SIGAR 16-16 Inspection Report

Afghan Ministry of Defense Headquarters:
\$154.7 Million Building Appears Well
Built, but Has Several Construction Issues
that Should Be Assessed

Figure 2 - Headquarters Building Sections Schematic

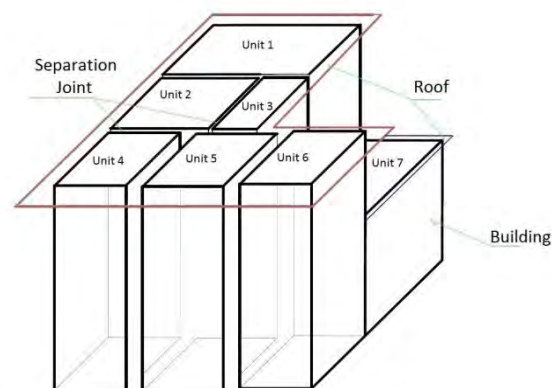
- The separation joints were not constructed according to the structural design drawings. The structural design drawings were deficient because they identified 200 millimeters as the maximum width but did not provide more specific widths based on the seismic design calculations for each of the separation joints. However, the separations joints were constructed in compliance with the seismic design calculations and will handle movement caused by seismic activity. Building Unit 2 seismic design calculations of the building movement exceeds the maximum allowable movement according to American Society of Civil Engineers standard 7 Table 12.12.1, occupancy category IV, for a 5-story building.

- Not all of the separation joints were aligned vertically from the foundation up to and through the roof of the building, as the contract design documents required (see photos 1 and 2 showing that the separation joints are not continuous.) As a result, the seismic calculations used are not valid. Most significantly, a structural failure of the concrete frame could result in occupants being harmed and the affected areas being rendered unusable until repairs are made. We requested Quality Assurance/Quality Control reports and photographs from AFCEC for the period of the concrete pour and form removal of specific areas. However, we did not receive the reports or photographs for the separation joints that concerned us.

- Some separation joints that we were able to observe without destructive testing, which would require us to damage finishes on the inside of the building, were spanned with non-structural systems, such as drain pipes, dropped ceiling framing, and inflexible gypsum wall board (sheet rock), without flexible

- 1. Assess the building's structural integrity where separation joints are not a continuous line from the bottom to the top of the building and the allowable building movement exceeds standards, and if needed, make deficient areas structurally sound.**
- 2. Assess the need for the installation of seismic lateral bracing on non-structural components suspended from the ceiling or floor above, such as heating/cooling equipment, duct work, dropped ceilings, electrical fixtures, and drain pipes.**

3. **Install flexible connections across all separation joints of non-structural components, such as gypsum wall board, dropped ceilings, and drain pipes.**
4. **Assess the integrity of lateral bracing, anchorage, isolation, and energy dissipation of all equipment for compliance with the contract's seismic requirements, and make deficient items compliant with the requirements.**
5. **Assess the installed roof drainage system for compliance with the design documents and the International Building Code, and correct any deficiencies.**

Figure 3 - Typical Seismic Restraints for Suspended Equipment

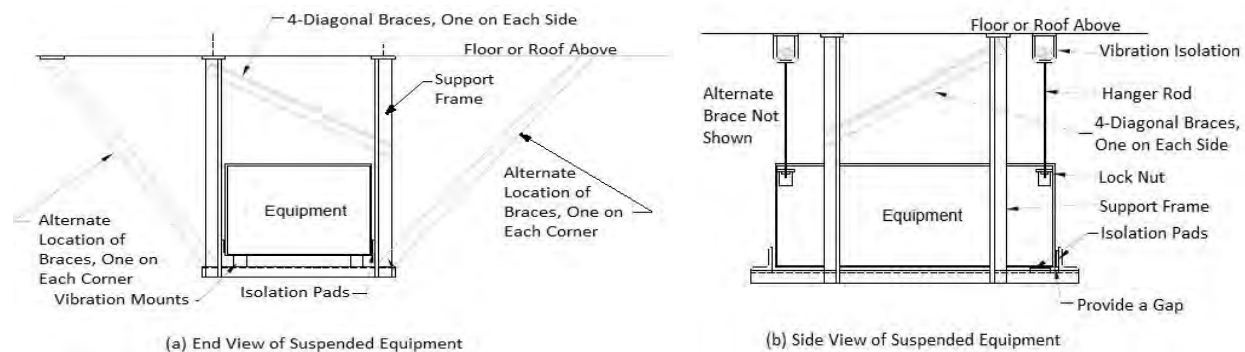
During our May 27, 2015, inspection, we found building equipment that did not have lateral bracing. Task orders 0030 and TG06 required that electrical and structural building standards, as defined in the Department of Defense's Unified Facilities Criteria, be followed in constructing the headquarters building.⁵ Based on the Unified Facilities Criteria, lateral bracing must be provided for items supported from the ceiling or floor above. Figure 3 shows typical seismic bracing, based on the Unified Facilities Criteria, used for equipment suspended from the ceiling or floor above.

According to the Unified Facilities Criteria and the American Society of Civil Engineers standard 7, all architectural, mechanical, and electrical components should be designed to include bracing, anchorage, isolation, and energy dissipation, as appropriate. This is because ceiling-mounted equipment, which includes heating/cooling equipment, mechanical duct work, and light fixtures, could swing freely during a seismic event and separate from their hangers and fall, damaging the equipment and possibly leading to injury.

Photo 3 shows a ceiling-mounted piece of heating/cooling equipment and mechanical duct work with no lateral bracing. In addition, the fuel supply for the fire suppression pump in the basement was installed without lateral bracing, isolation joints, or containment.⁶ In a seismic event, the elevated 238-gallon diesel fuel tank could spill fuel across the pump room floor. The fuel would then leak into the rain water collection system, be directed to the wastewater treatment plant, and ultimately discharged into the Kabul River.

Figure 4 - Example of Secondary Drain for a Roof with Parapet Walls

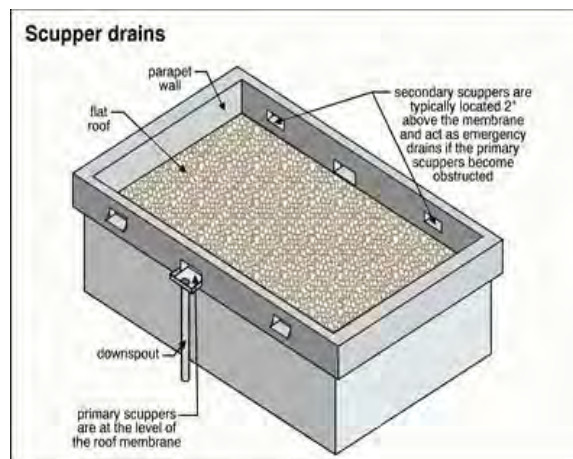
During our 2015 inspections, we found that the roof was not designed or constructed in accordance with the contract and code requirements for roof drainage.⁷ For example, we found that the installed roof drains measured 3 inches, not the 4 inches in diameter required by the ITSI engineers' revised calculations. In addition, secondary drains, known as scuppers, were not installed. The contract design documents required—as does the building code—a secondary emergency overflow for roofs with a parapet wall (see figure 4 showing examples of secondary emergency roof drains).⁸ Otherwise, if storm water is trapped on the roof behind the parapet walls, it could (1) damage the ventilation and heating/cooling equipment that is roof mounted on 4-inch high platforms, and (2) allow water to enter the roof access doors and flood the building causing damage to equipment and interior finishes.

Our inspections also revealed that water from one of the building's seven sections drains to and is collected in a pit in the basement floor that contains two pumps. These pumps require electricity, and if the power is interrupted or the system is not well maintained, the basement could flood, potentially damaging the fire suppression system and water supply pumps for the building, as well as servers and the switch control panel for the back-up power generators. The other six sections of the building's roof drain directly to sewage collection manholes around the building and then to the wastewater treatment plant.

We also found that the rain water from the roof drains could overload the wastewater treatment plant. The roof drains have the capacity to collect approximately 93,000 gallons of storm water and direct it to the wastewater treatment plant.⁹ The treatment plant drains into the Kabul River, as would any untreated overflow from an overwhelmed treatment plant. Best management practices discourage the mixing of storm water with sewage water. The wastewater treatment plant, which is capable of treating 203,000 gallons per day, is designed to receive 190,584 gallons of wastewater from the MOD headquarters building.¹⁰ As a result, adding an additional 93,000 gallons of rain water would exceed the wastewater treatment plant's capacity.

Lastly, if the roof does not drain within 48 hours as required by minimum standards referenced in the design documents, the standing water could increase maintenance and repair costs, and decrease the useful life of the roof. Further, standing water in the winter could freeze and cause damage to the roof's membrane and roof equipment supports.¹¹

Photo 4 - Handrail Is 31 Inches in Height and Is Dented

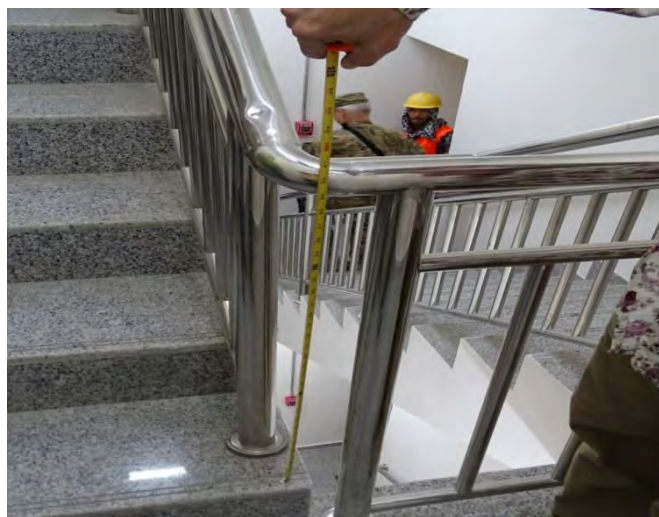
We found that the handrails on interior stairways were not installed at the proper height. During our May 27, 2015, site inspection, we measured the handrail height at 31 inches, which does not meet the minimum 34-inch height required by the International Building Code (see photo 4 showing the lower than required handrail height).¹² The 34-inch handrail height is standardized to allow the average person to reach for the handrail at an average height, so a lower height could contribute to falls on the stairways and injuries.

We also found that the handrail material was insufficient in quality. Our review of construction documents showed that the originally specified handrail material was mild steel pipe, but that AFCEC approved ITSI's request to substitute stainless steel thin-

walled pipe.¹³ The walls of the stainless steel pipe are no more than a fourth as thick as the originally required pipe. As a result, we found that the installed handrail has multiple dents, which is common for stainless steel thin-walled pipe. The substitution to the thin-walled stainless steel pipe will result in increased maintenance costs for the handrails, which run the risk of being dented further when furniture is moved into the building.

Our draft report included a sixth recommendation for CSTC-A to address the defective handrails. In its comments, CSTC-A informed us that Gilbane Federal corrected the height of the handrails in November 2015. We confirmed during our post-earthquake inspection on January 7, 2016, that CSTC-A acted on the recommendation and corrected the handrails. Therefore, we did not repeat the sixth recommendation in our final report.
